**Screening Report,**

Environmental Assessment and Review Process Guidelines Order

Regional Environmental Review Committee,

**Brewery Creek Heap Leach Gold Mine Project**

FIGURE 3 HEAP LEACH PAD LINER

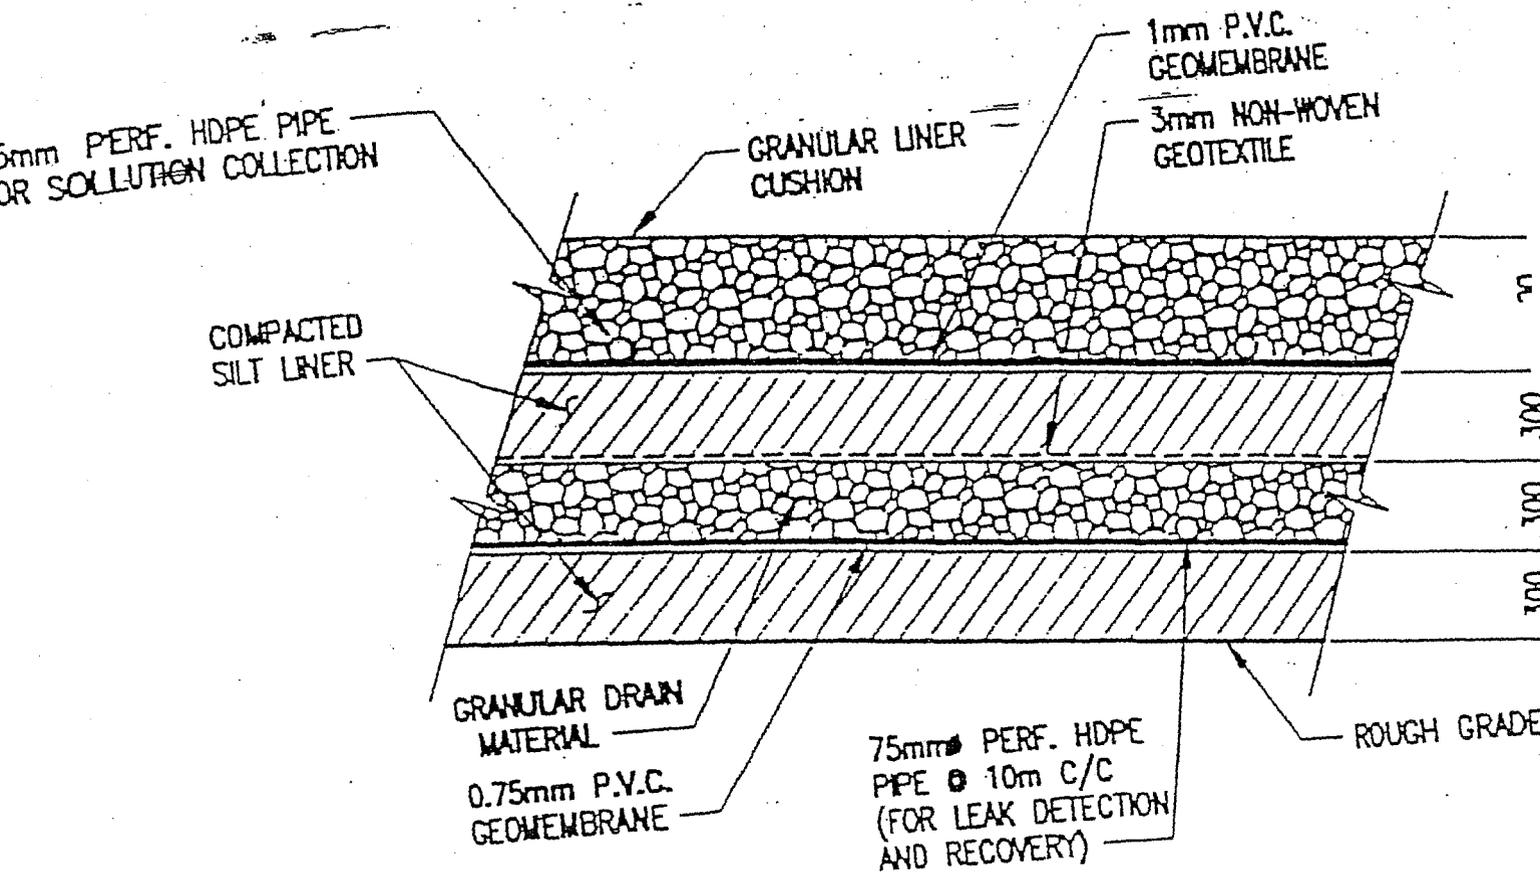
On February 15, 1995, in consultation with DIAND and DIAND consultants, Loki and their consultant proposed revisions to the liner system to address the above concerns (Figure 3). Revisions included addition of a 0.75 mm thick PVC geomembrane liner below the leak detection and recovery system (LDRS) to ensure rapid reporting of leaks in the primary composite liner and an increase to the LDRS layer from 75 mm to 150 mm and finally to 300 mm. This resulted in a double geocomposite liner which placed less reliance on the silt permeability (and field assurance), added redundancy in the liner system, and offered a more predictable leak detection performance and more effective construction control.

The company must construct and operate the heap leach pad and supporting facilities according to design specifications contained in "Loki Gold Corporation, Brewery Creek Mine, Design Criteria Report", (Design Criteria Report) and, "Loki Gold Corporation, Brewery Creek Mine, Technical Specifications",. The heap leach pad and supporting facilities must be constructed according to "Loki Gold Corporation, Brewery Creek Mine, Construction Quality Assurance Manual", (CQA Manual). Detailed, as-built construction drawings must be filed with the Yukon Territory Water Board (YTWB) after completion of each phase of construction.
